Access Compliance Report

(Curb Ramps)

Intersection ID: 16513	Main Street: BILTMORE_DR	Cross Street: COLVILLE_RD	Location: SW
ADA ID: CF7260803404	Ramp Type: Perp	Initial Pass/Fail: Fail	Overall Compliance: No
Codes/Mitigation Info/Possible Solution		Field Measurements/Component Compliance	
Severity Score: 13.75

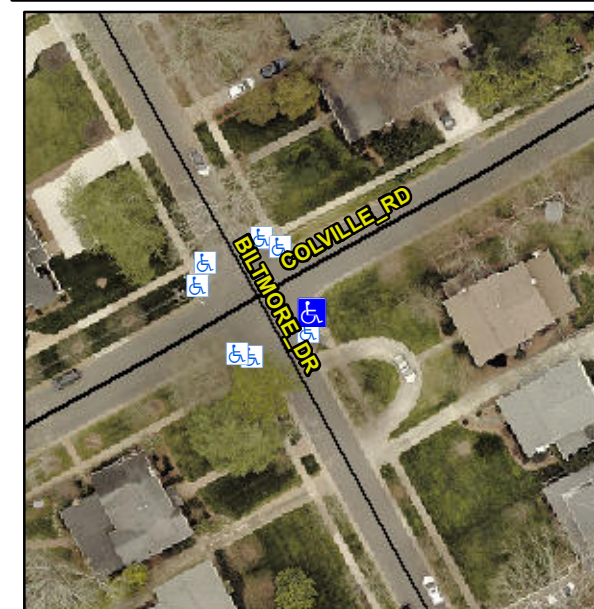
R304.2.2, R304.5.3

Compliance	Description	Data	Compliance	Description	Data
N/A	Ramp Length (in)	68.0	No	Ramp Slope (%)	8.7
Yes	Ramp Width (in)	70.0	No	Ramp XSlope (%)	3.9
N/A	Flare Type LT	N/A	N/A	Flare Type RT	N/A
N/A	Flare Slope LT (%)	N/A	N/A	Flare Slope RT (%)	N/A
N/A	Flare Traversable LT?	N/A	N/A	Flare Traversable RT?	N/A
N/A	Landing Length (in)	N/A	N/A	DWS Provided?	N/A
N/A	Landing Width (in)	N/A	N/A	DWS Contrast?	N/A
N/A	Landing Slope (%)	N/A	N/A	DWS Length (in)	N/A
N/A	Landing X Slope (%)	N/A	N/A	DWS Full Width?	N/A
N/A	Landing Curb? (Y/N)	N/A	N/A	DWS Offset (in)	N/A
N/A	Shared Landing?	N/A			
N/A	Gutter Ponding?	N/A	N/A	Gutter Slope (%)	N/A
N/A	Gutter Lip Ht (in)	N/A	N/A	Gutter X Slope (%)	N/A
N/A	Painted X Walk1?	No	N/A	Painted X Walk2?	N/A
	X Walk 1 Direction	To N		X Walk 2 Direction	N/A
N/A	X Walk 1 Width (in)	N/A	N/A	X Walk 2 Width (in)	N/A
	X Walk 1 Slope (%)	2.9		X Walk 2 Slope (%)	N/A
	X Walk 1 X Slope (%)	1.0		X Walk 2 X Slope (%)	N/A

Remove & Replace Entire Ramp.
